May 26, 2021

**RE: MUSSEY GRADE ROAD ALLIANCE COMMENTS ON 2023-2025 WILDFIRE  
MITIGATION PLANS OF PG&E, SCE, AND SDG&E**

**Figure 19** - Figure SCE 6-12 - Fire Size at 8 Hours Relative to Final Fire Size.<sup>150</sup>

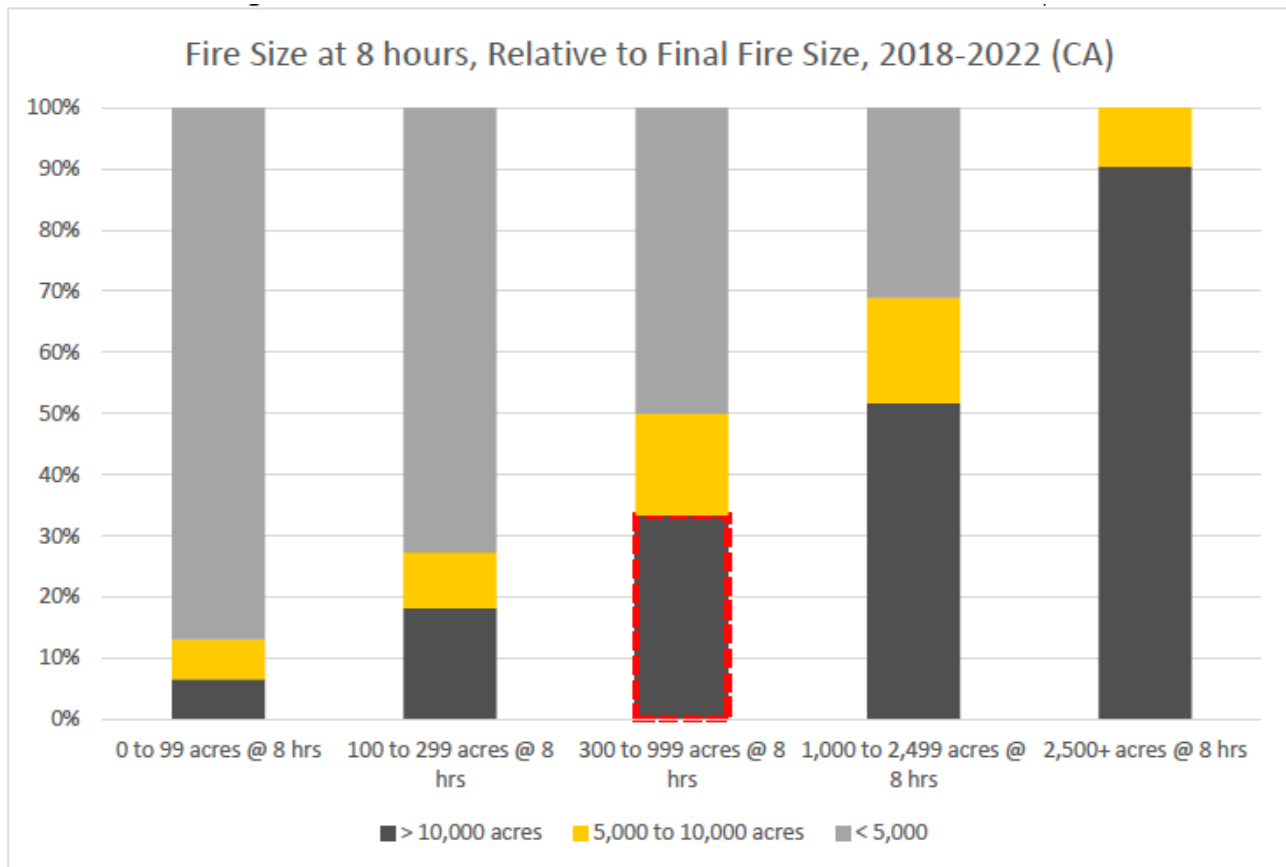
Rather than incorporate this information as a binary classification criterion in its IWMS framework, SCE should work instead to generate correct consequences from its MARS framework. For instance, the distribution of the data in the graph above could be fit to power law distribution and used in a Monte Carlo to generate final consequences given the Technosylva 8 hour fire size as input.

**Figure 21** – Diagram of SDG&E’s WiNGS Planning decision tree.<sup>168</sup>

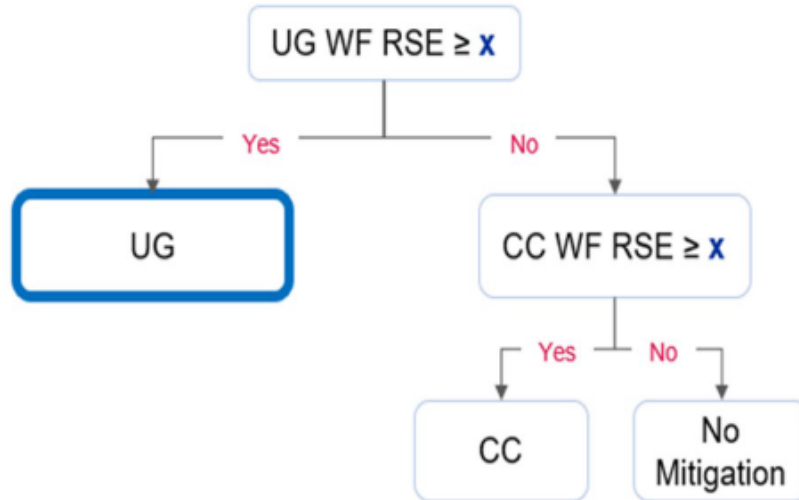
By allocating all the riskiest circuits to UG, SDG&E reserves the lower-risk circuits for CC, thus ensuring that the remaining CC circuits have a poor RSE.

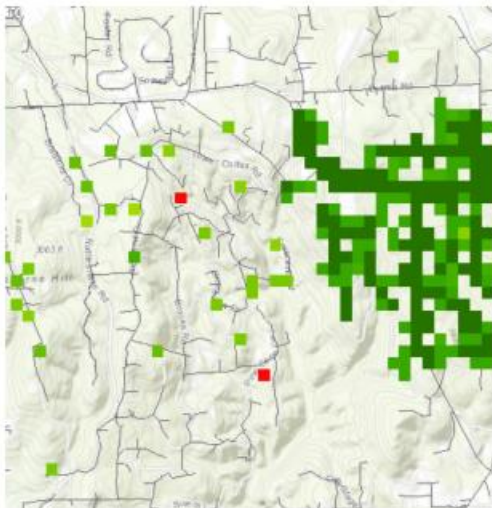
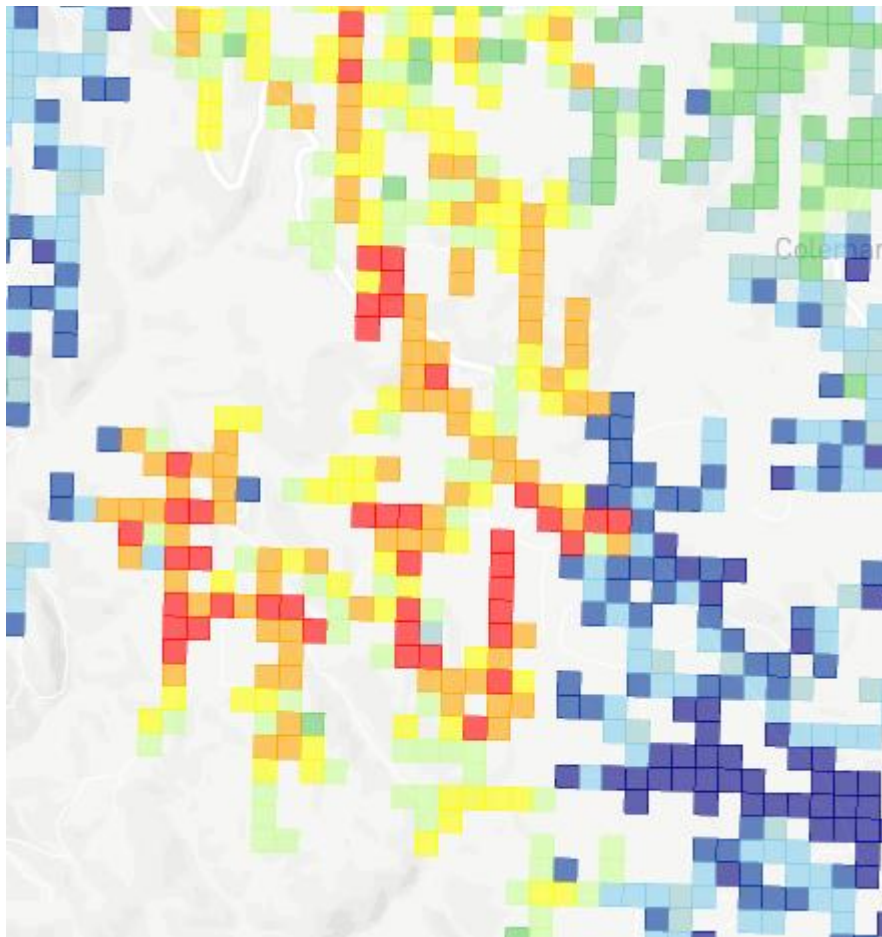
Please explain why isolated “hot polygons” appear in the data, as shown below, and whether these represent actual risk or an artifact.

It is difficult to determine the location of the provided example based on the information provided. Orphaned pixels, such as those shown in the example, may result from missing pixels due to incomplete data or processing of the data. At the pixel-by-pixel level, the model does exhibit some level of noise that can result in high-risk hot spots in an area of generally lower risk pixels. As seen in the example below, low risk and high-risk pixels can mix locally. For this reason, workplan development is generally guided by circuit segment level aggregations that provide an improved indication of risk level.
